Access Compliance Report

Public Rights-of-Way

Intersection ID: 12704	Main Street: E_5TH_ST	Cross Street: N_DAVIDSON_ST	Location: W
ADA ID: 512FFE72AEB6	Ramp Type: PerpDiag	Initial Pass/Fail: Fail	Overall Compliance: No
			Severity Score: 21.25

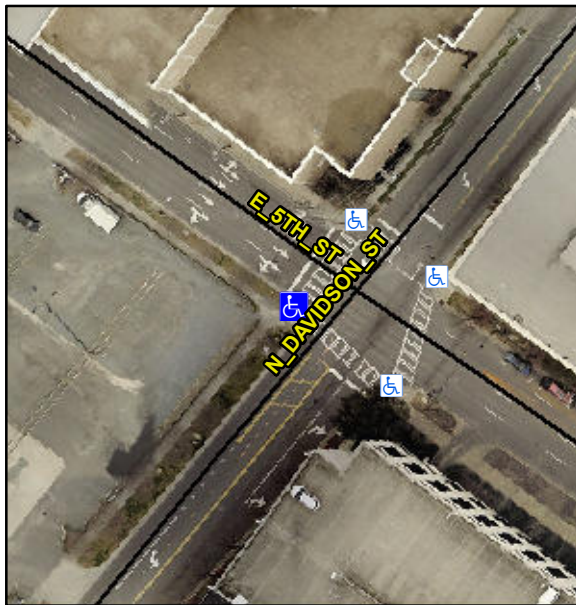
Not Found, R304.5.1, R304.2.2

Compliance	Description	Data	Compliance	Description	Data
N/A	Ramp Length (in)	96.0	No	Ramp Slope (%)	11.1
No	Ramp Width (in)	42.5	Yes	Ramp XSlope (%)	0.1
N/A	Flare Type LT	N/A	N/A	Flare Type RT	N/A
N/A	Flare Slope LT (%)	N/A	N/A	Flare Slope RT (%)	N/A
N/A	Flare Traversable LT?	N/A	N/A	Flare Traversable RT?	N/A
N/A	Landing Length (in)	N/A	N/A	DWS Provided?	N/A
N/A	Landing Width (in)	N/A	N/A	DWS Contrast?	N/A
N/A	Landing Slope (%)	N/A	N/A	DWS Length (in)	N/A
N/A	Landing X Slope (%)	N/A	N/A	DWS Full Width?	N/A
N/A	Landing Curb? (Y/N)	N/A	N/A	DWS Offset (in)	N/A
N/A	Shared Landing?	N/A			
N/A	Gutter Ponding?	N/A	N/A	Gutter Slope (%)	N/A
N/A	Gutter Lip Ht (in)	N/A	N/A	Gutter X Slope (%)	N/A
N/A	Painted X Walk1?	Yes	N/A	Painted X Walk2?	Yes
	X Walk 1 Direction	To SE		X Walk 2 Direction	To NE
N/A	X Walk 1 Width (in)	84.0	N/A	X Walk 2 Width (in)	104.0
	X Walk 1 Slope (%)	4.4		X Walk 2 Slope (%)	1.8
	X Walk 1 X Slope (%)	3.1		X Walk 2 X Slope (%)	2.4

Remove & Replace Curb Ramp With Two New Directional Ramps or Equivalent.
